# Determination 2025/035

**Compliance of horizontal rusticated weatherboard wall cladding as-built with double-nail fixings with Clauses B2 and E2**

**2 Ngake Street, Orakei, Auckland**

**Figure 2: as-built construction (Indicative and not to scale)**

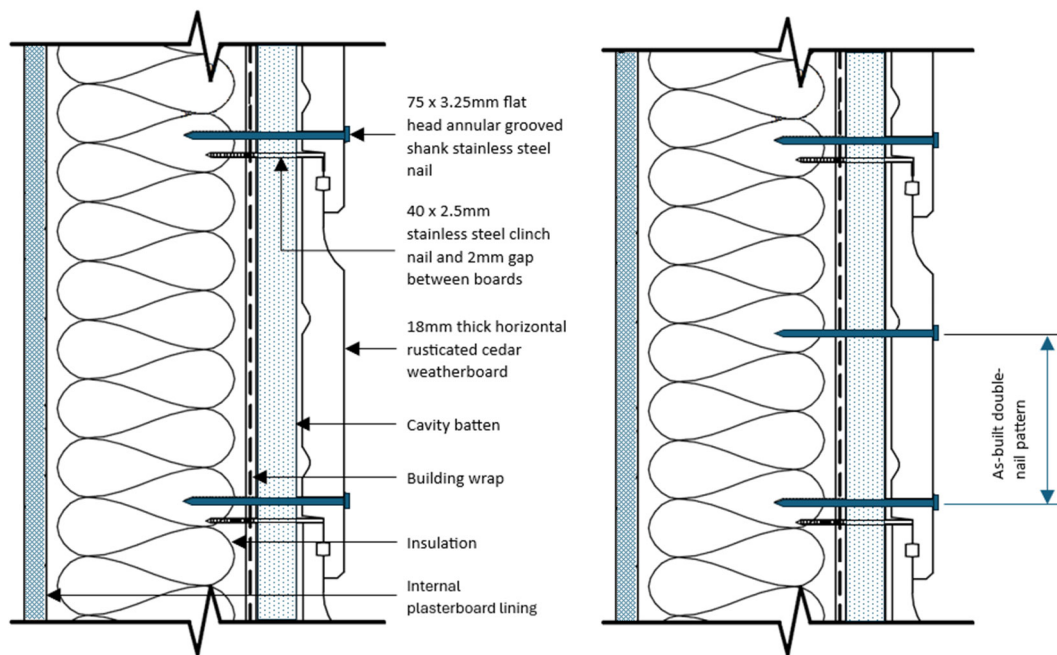
- 1.4. The as-built weatherboards have been fixed using a pattern of double nails, ie one nail above an another (refer to Figure 2). The authority has not accepted the fixing arrangement because the cladding has not been installed in accordance with the manufacturer’s specifications, which relies on a single nail fixing arrangement.

- 2.6. A further inspection by the authority on 18 July 2024 noted 'sighted double nailing on boards. Confirmation required on double nailing from manufacturer'.<sup>(5)(6)</sup>

- 3.2.4. “The current construction of the weatherboard cladding system does not comply” with clause E2.3.2 because the double nailing of weatherboards is outside the product manufacturers specifications. The issue or potential

- 3.2.5. In respect of clause B2, split weatherboards, double nail fixing and overdriven fixings have the potential for increasing current splits or further splits and/or moisture retention in the face of the weatherboard. Further, dark stain with an unknown Light Reflectance Value may have contributed to the cupping of weatherboards.

4.19. The photos show the weatherboards clearly have a range of defects, especially along the north elevation, and some weatherboards have already been replaced due to these defects. I consider the combination of the double-nail fixing arrangement, the dark stain finish/coating, and lack of maintenance via the deterioration of the stain finish/coating have contributed to and resulted in the splits and cupping of the boards. This arrangement has restricted the expansion and contraction ability of the weatherboards, forming splits and cupping. Further, the

- 5.1. In accordance with section 188 of the Building Act 2004, I determine the horizontal rusticated cedar weatherboards as-built with double-nail fixing pattern, does not comply with clause B2.3.2(b) in respect of clause E2.3.2 for the minimum required durability period in those areas where splitting and cupping has occurred.
